ADDENDUM NO. 3

RE: Cox Creek, Goldfish Farm Road Bridge Replacement
Bid Opening, February 18, 2025, 9:35 PDT, Linn County Courthouse

The following changes are hereby made to the Cox Creek, Goldfish Farm Road Bridge Replacement Project Bidding Documents:

SHEET 6

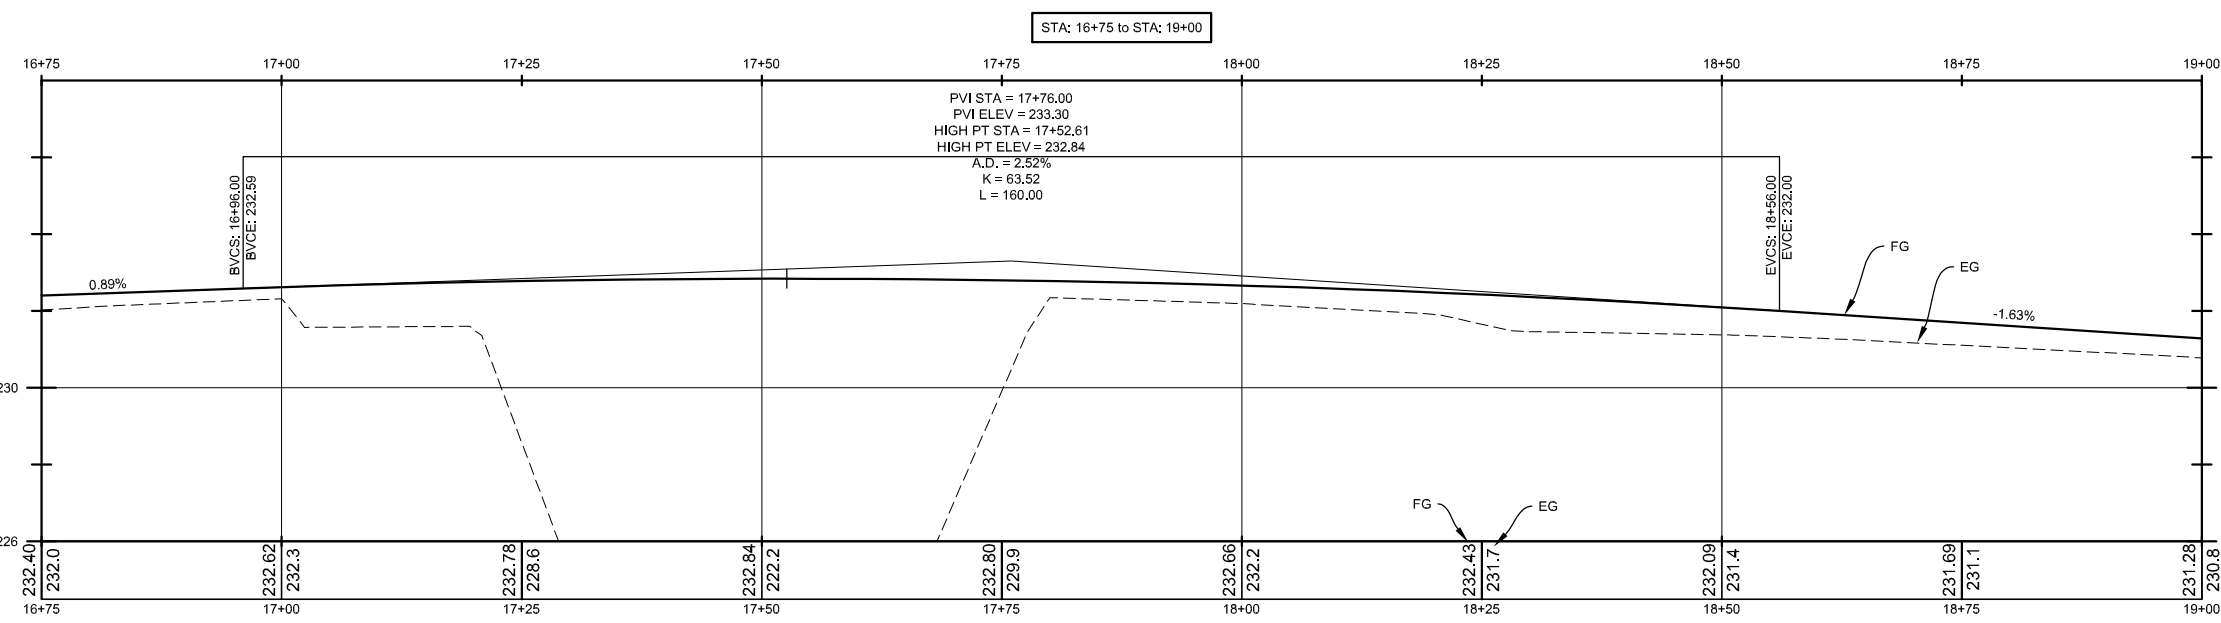
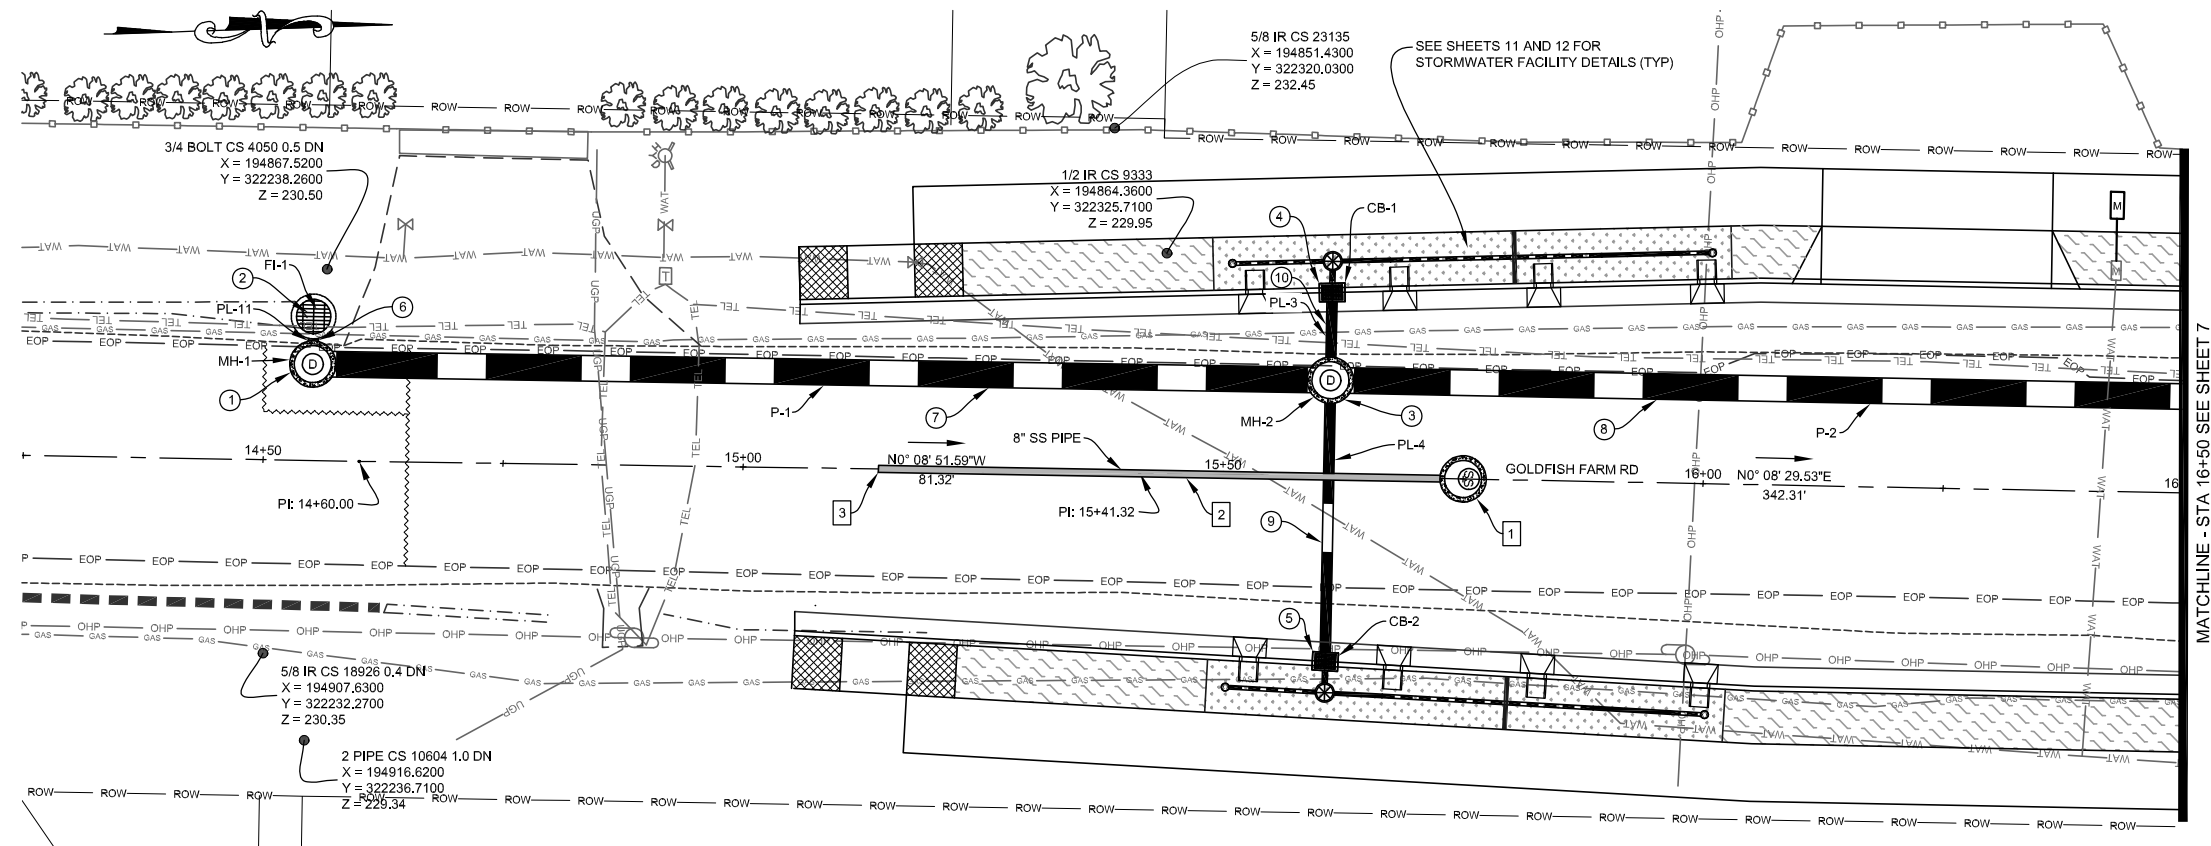
Sheet 6 – Note was added regarding the fire hydrant installation.

DATE:	REVISION:	BY:	BRIDGE NO:	DATE:
1/28/25	NO FENCE TO BE RELOCATED	SSM	0328-0036	1/15/2025
2/13/25	ADDED FIRE HYDRANT NOTE	SSM	PROJECT NO: CB2101	
			TRS: T, 11 S., R, 03 W., SEC. 10	
			DESIGNED BY: D. Malone	CHECKED BY: D. Malone
			DRAFTED BY: S. MacLean	REVIEWED BY: K. Groom

SHEET 8

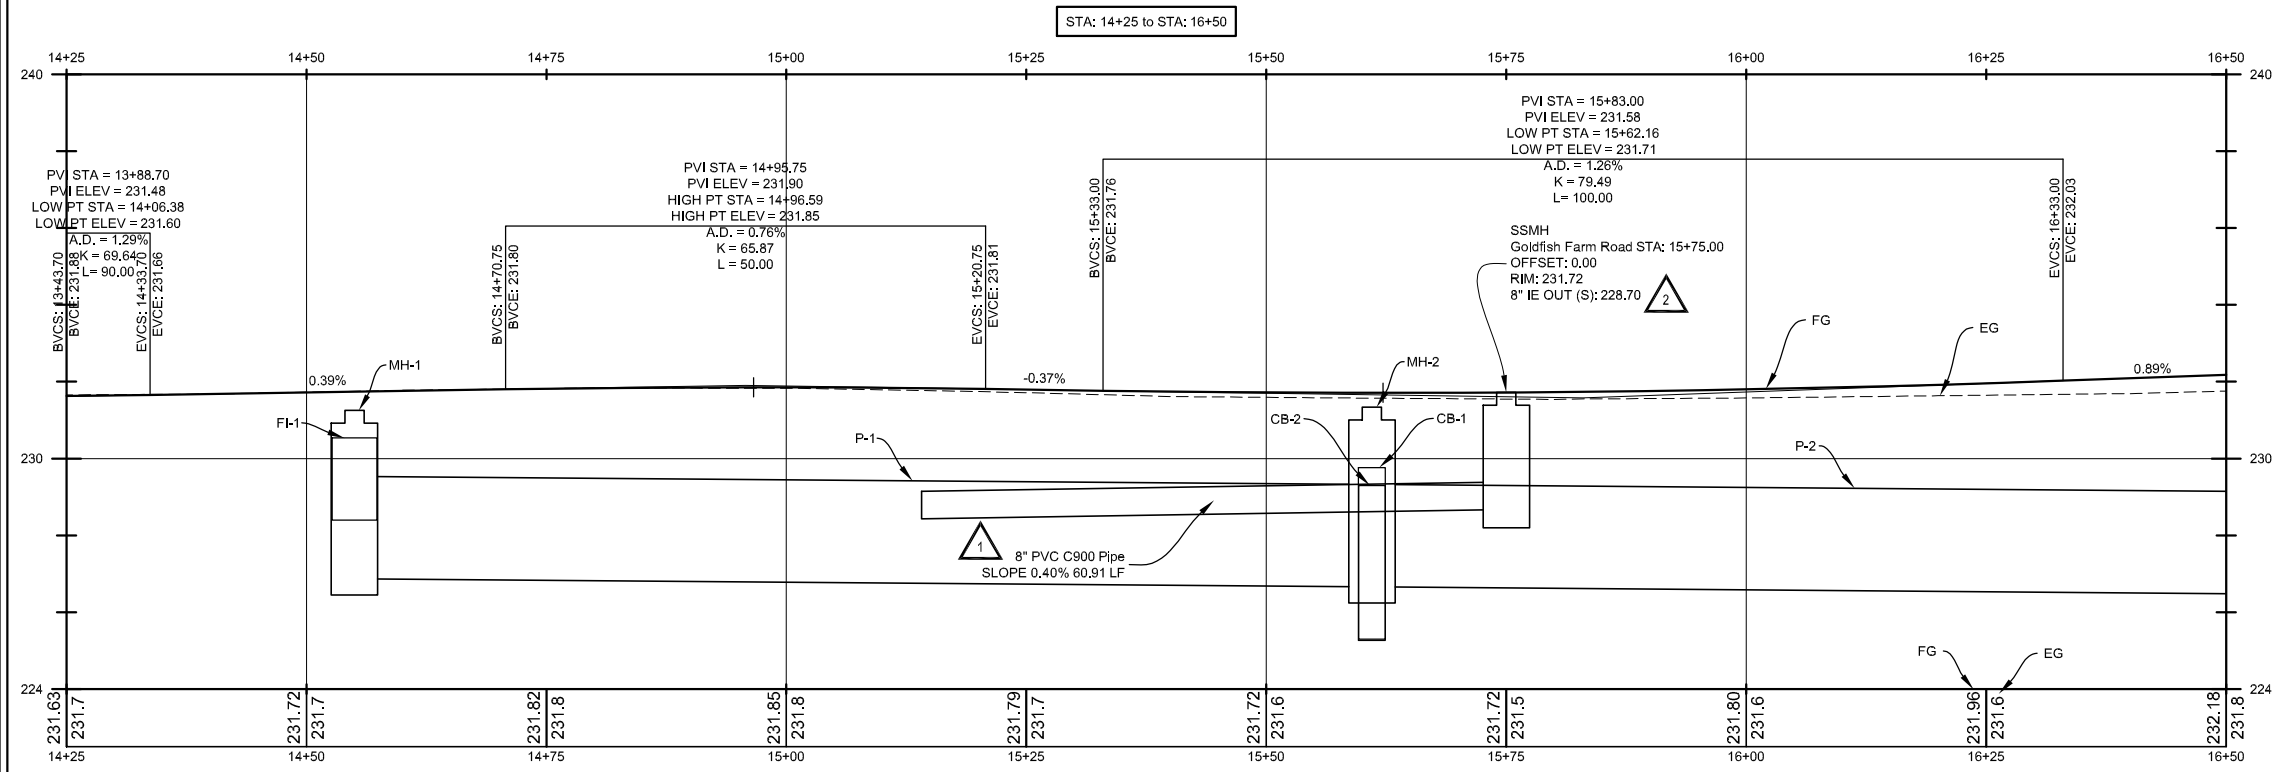
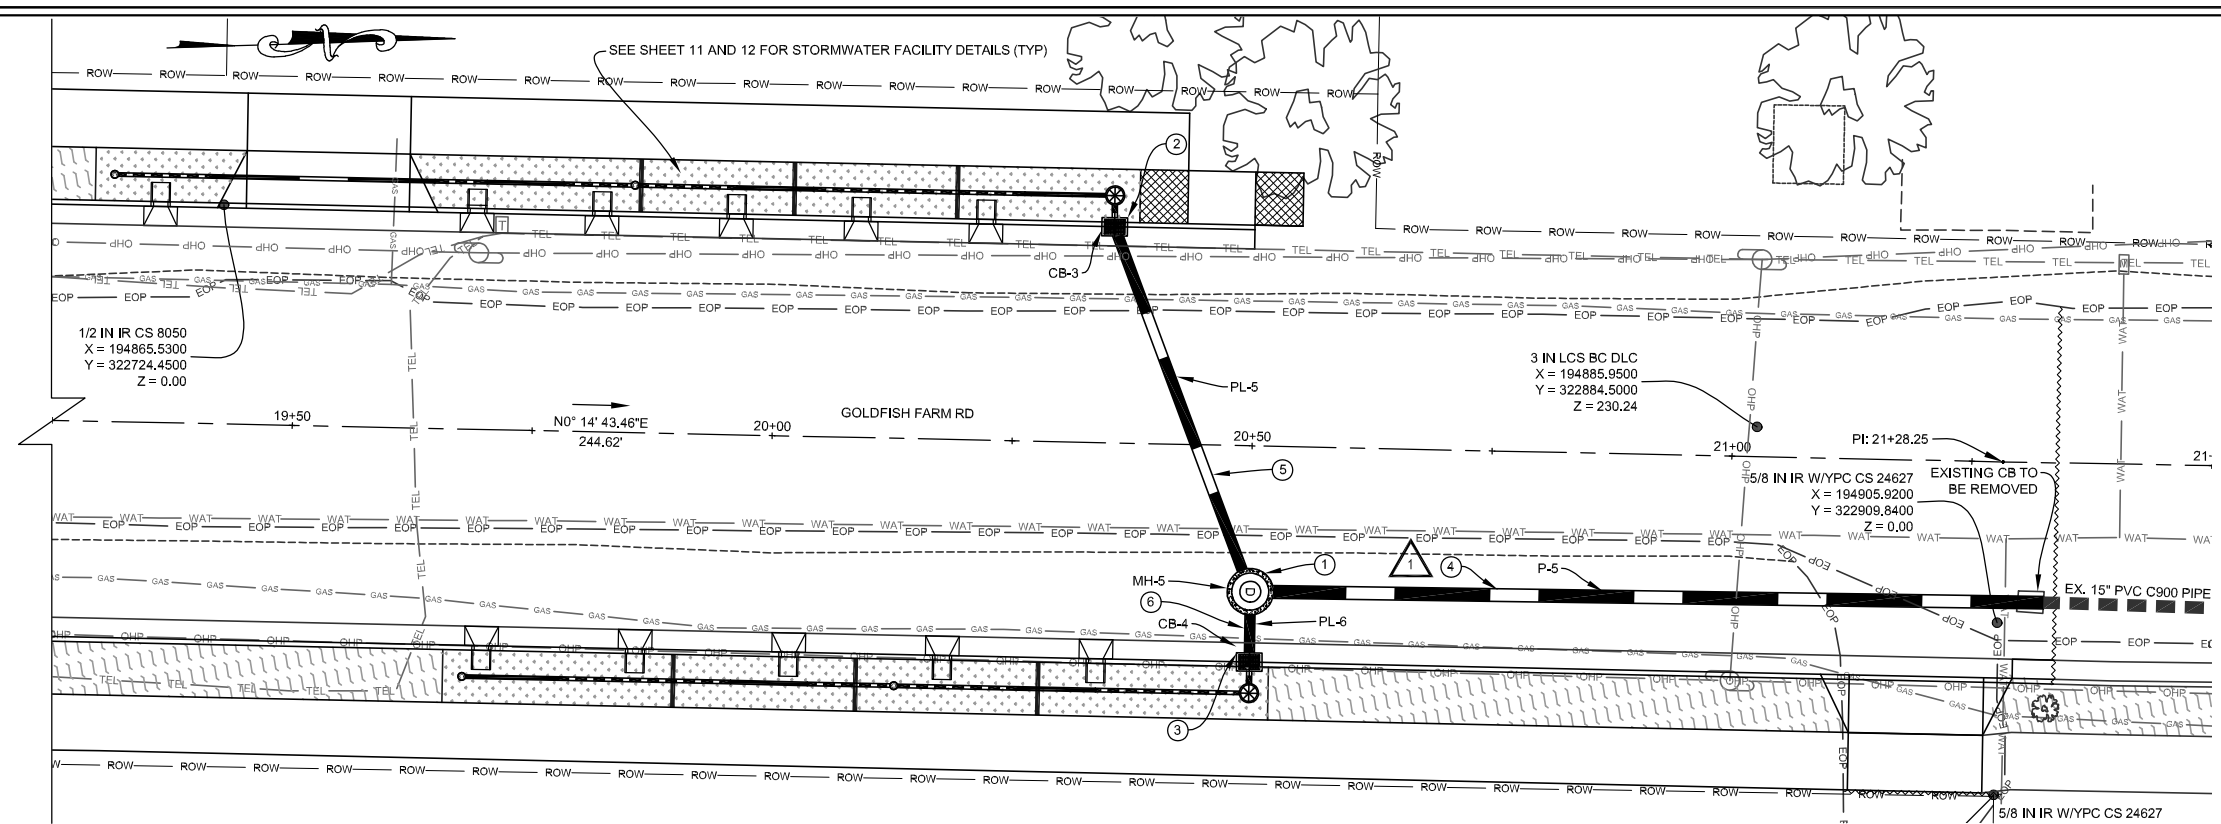
Sheet 8 – Sanitary sewer pipe type and elevation was modified.

DATE:	REVISION:	BY:	BRIDGE NO:	DATE:
2/13/25	CHANGED PIPE TYPE TO C900	SSM	0328-0036	1/15/2025
2/13/25	CHANGED PIPE INVERT ELEVATION	SSM	PROJECT NO: CB2101	
			TRS: T. 11 S., R. 03 W., SEC. 10	
			DESIGNED BY: D. Malone	CHECKED BY: D. Malone
			DRAFTED BY: S. MacLean	REVIEWED BY: K. Groom

SHEET 10

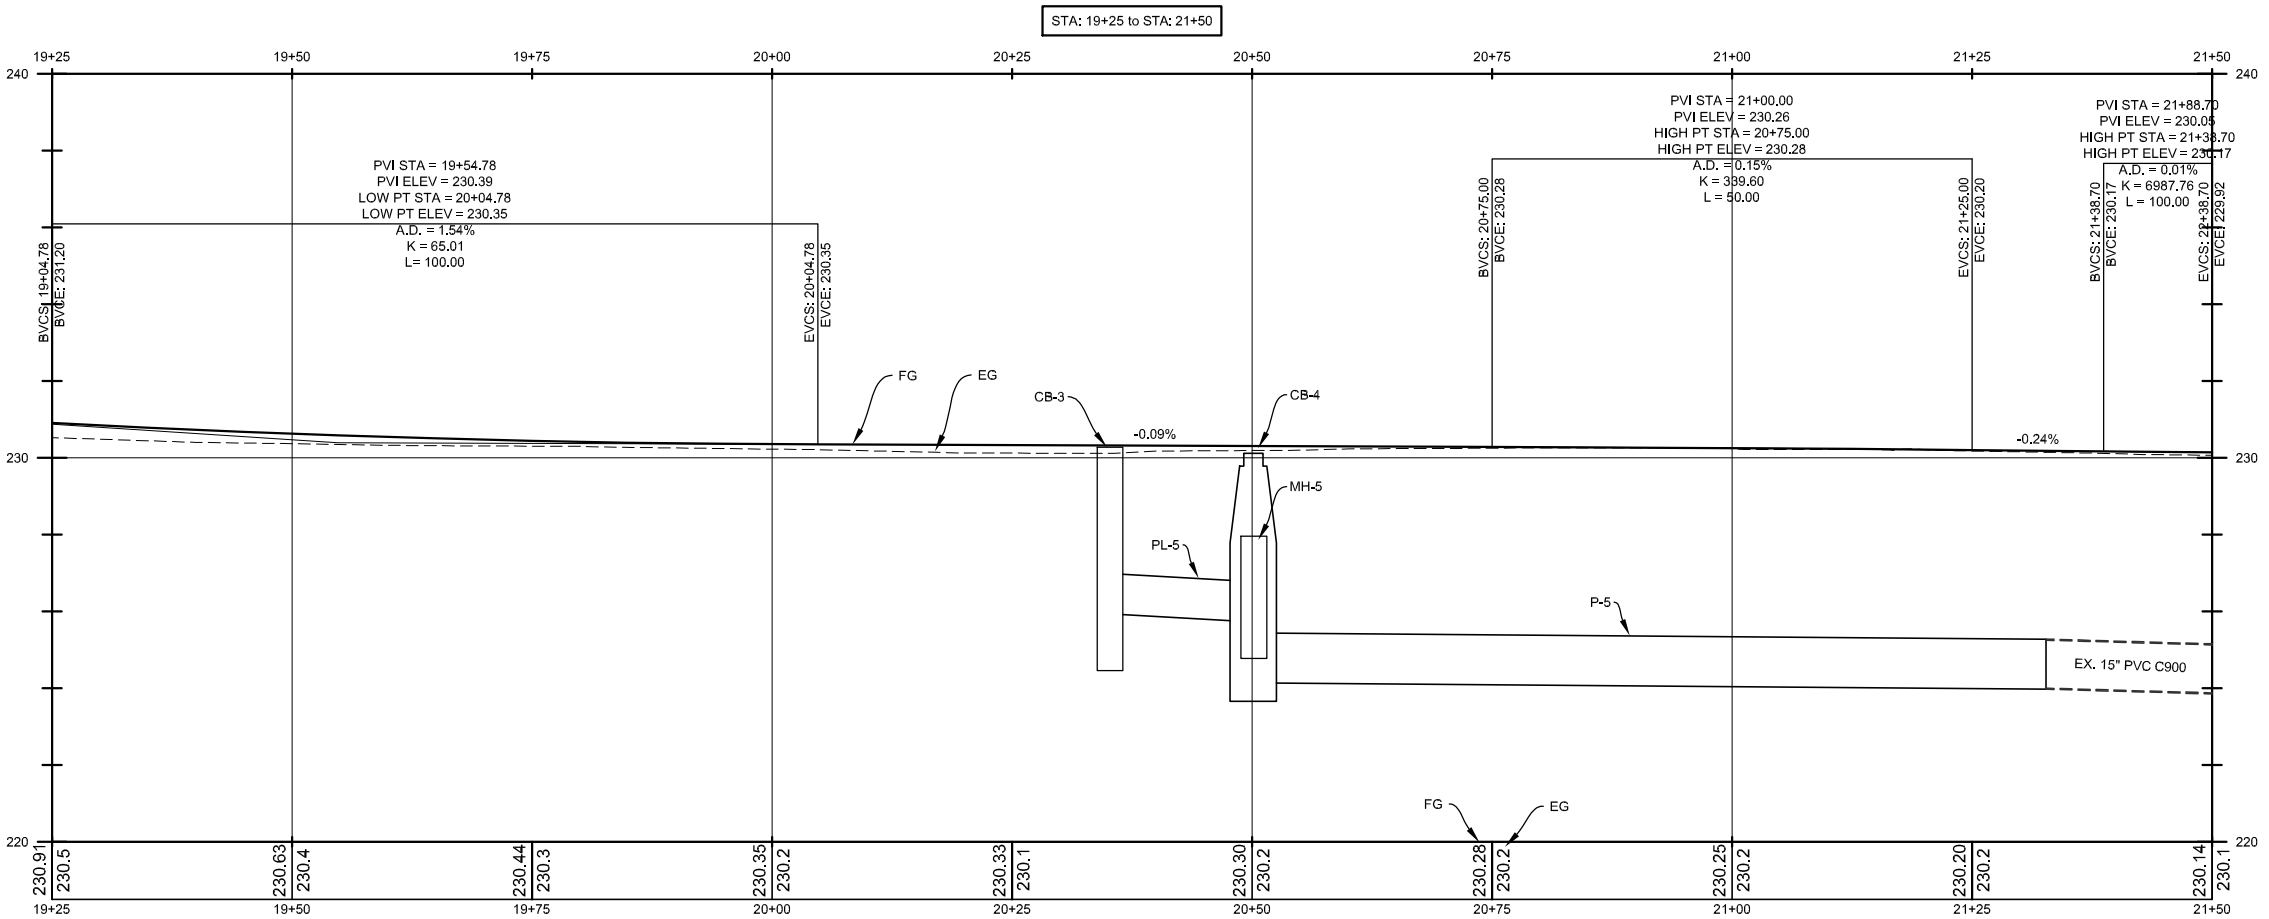
Sheet 10 – Storm sewer pipe size was modified.

DATE:	REVISION:	BY:	BRIDGE NO:	DATE:
2/13/25	④ CHANGED PIPE SIZE FROM 12" TO 15"	SSM	0328-0036	1/15/2025
			PROJECT NO: CB2101	
			TRS: T. 11 S., R. 03 W., SEC. 10	
			DESIGNED BY: D. Malone	CHECKED BY: D. Malone
			DRAFTED BY: S. MacLean	REVIEWED BY: K. Groom

SHEET 11

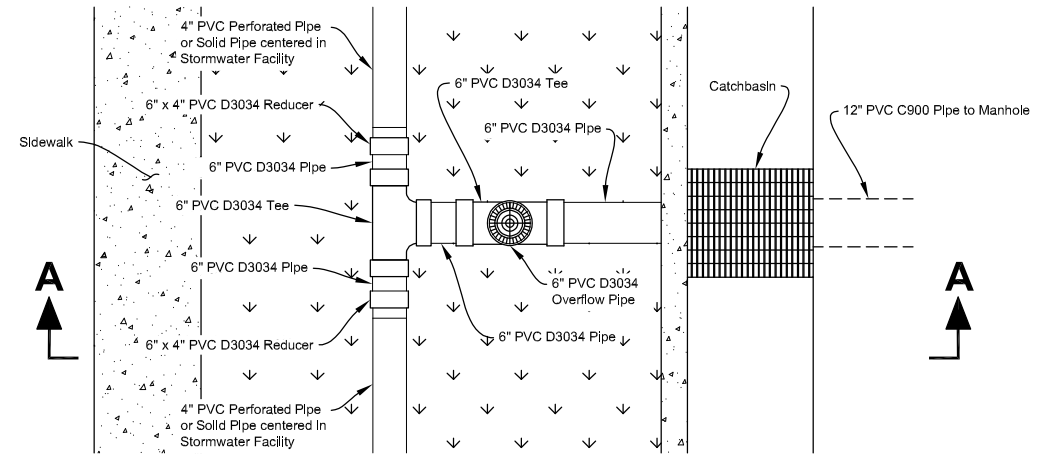
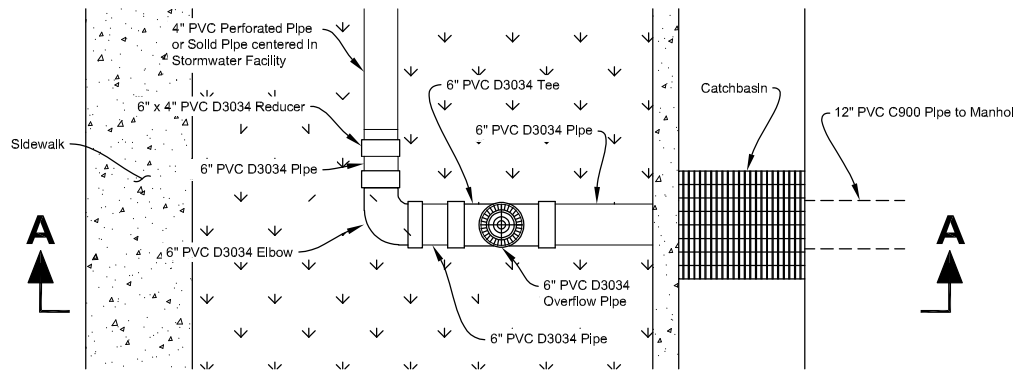
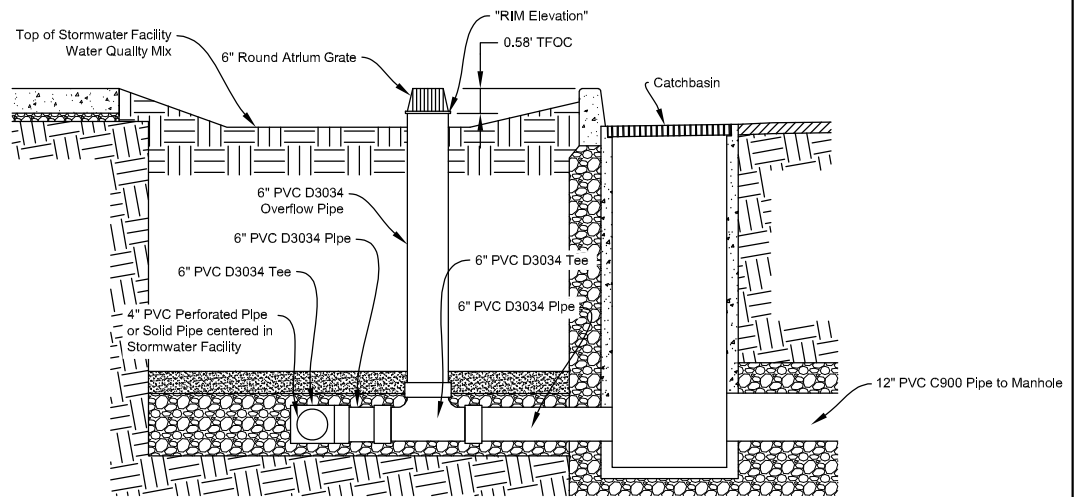
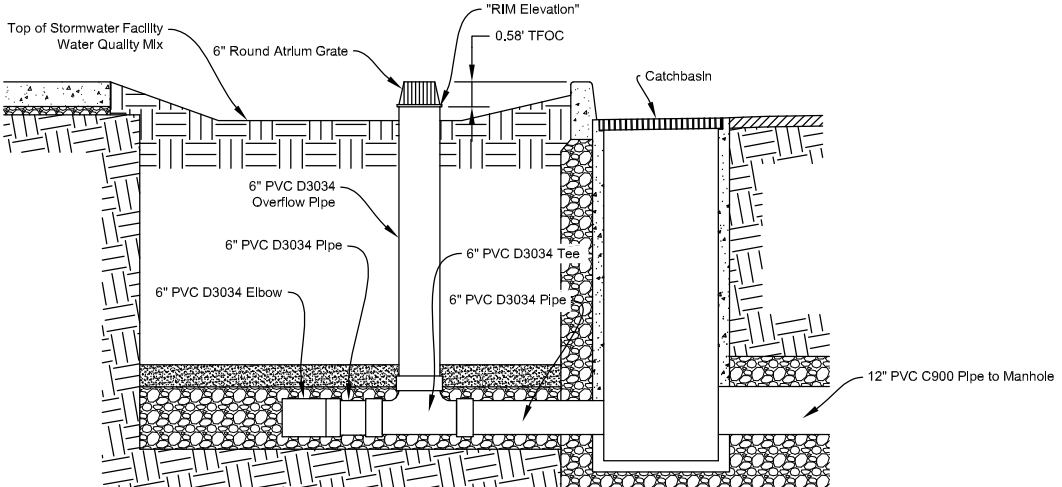
Sheet 11– Storm sewer pipe size was modified.

DATE:	REVISION:	BY:	BRIDGE NO:	DATE:
1/28/25	STORM DRAIN OUTFALL RELOCATED	SSM	0328-0036	1/15/2025
2/13/25	CHANGED PIPE SIZE FROM 12" TO 15"	SSM	PROJECT NO: CB2101	
			TRS: T. 11 S., R. 03 W., SEC. 10	
			DESIGNED BY: D. Malone	CHECKED BY: D. Malone
			DRAFTED BY: S. MacLean	REVIEWED BY: K. Groom
